## Sporting Bulletin no. 5

**Subject:** Sealing of the Junior CrossCar Restrictors and Throttle Body.

### A. Sealing of the Restrictors

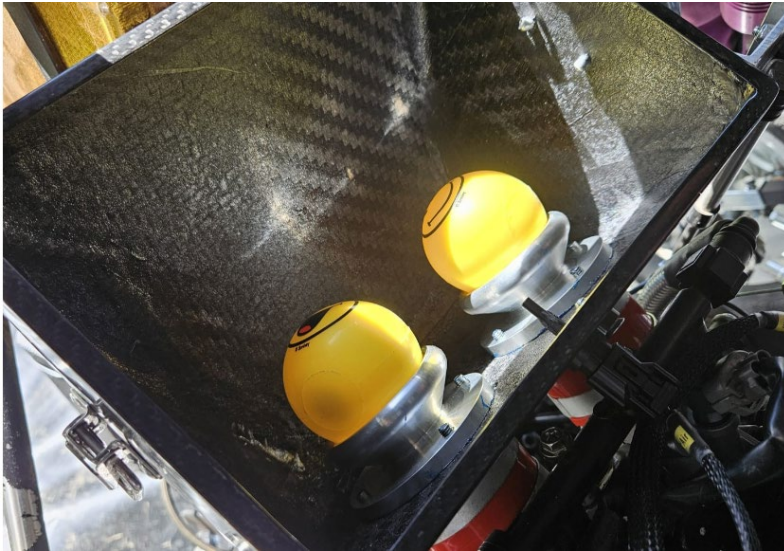
For the 2025 season, all Junior CrossCar restrictors will be sealed. The sealing will be done from the mounting clamps on the restrictors to the mounting clamps on the throttle unit.

The fixing of the restrictors onto the throttle unit must only be carried out with superclamps.

The teams must prepare the heads of the screws of the superclamps with a 2.5-mm bore and connect the heads of the screws with  $\varnothing$  0.8mm locking wire so that they can be sealed.

The FIA seals will be affixed by the FIA Technical Delegate during the pre-event scrutineering.

### B. Sealing of the Throttle Body

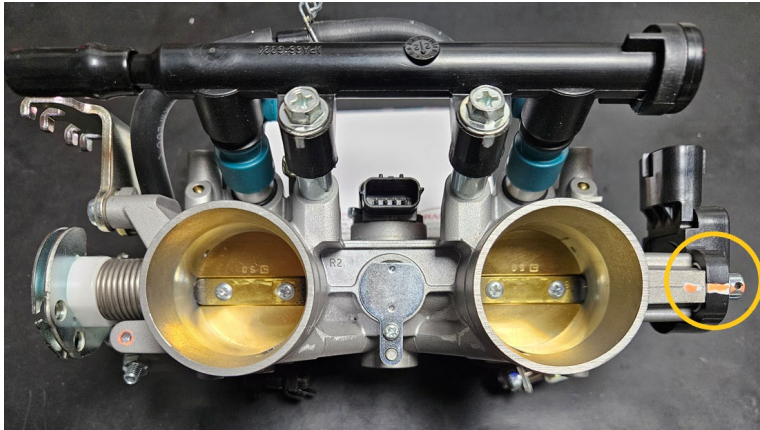
For the 2025 season, all Junior CrossCar throttle bodies will be sealed.

The teams must prepare the throttle body as follows:

- a) A 3mm hole must be drilled on the throttle body. The position see below.

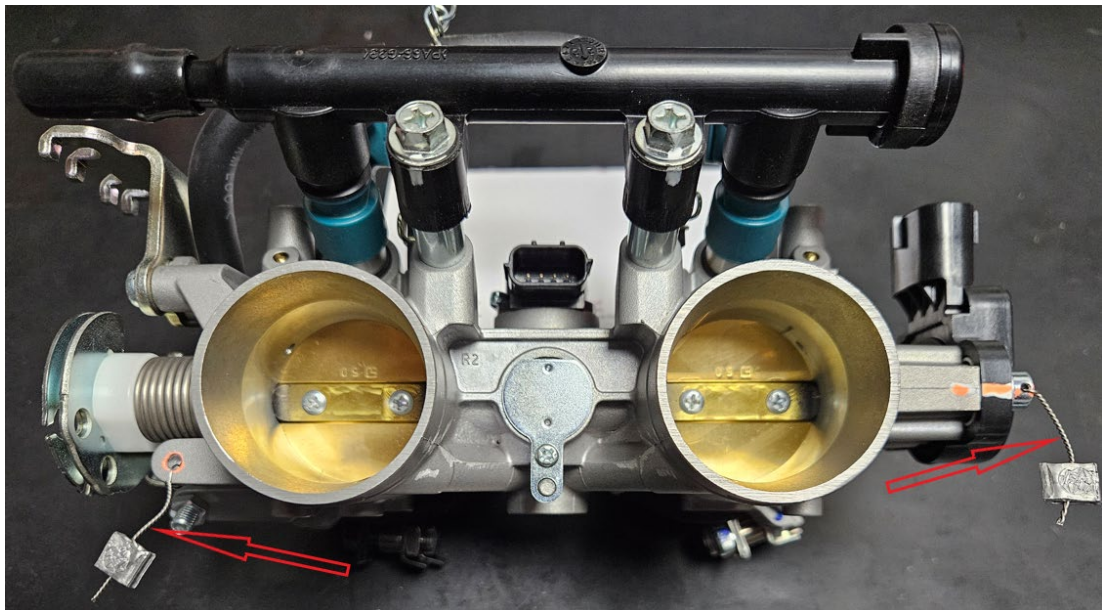
- b) The original potentiometer fixing bolt must be replaced with a prepared M5x12mm Allen head bolt. A 2.5 mm hole must be drilled to the Allen head of the bolt.

- c)  $\varnothing$  0.8mm locking wire must be fitted to the two below indicated positions so that the FIA seals can be affixed by the FIA Technical Delegate during the pre-event scrutineering.
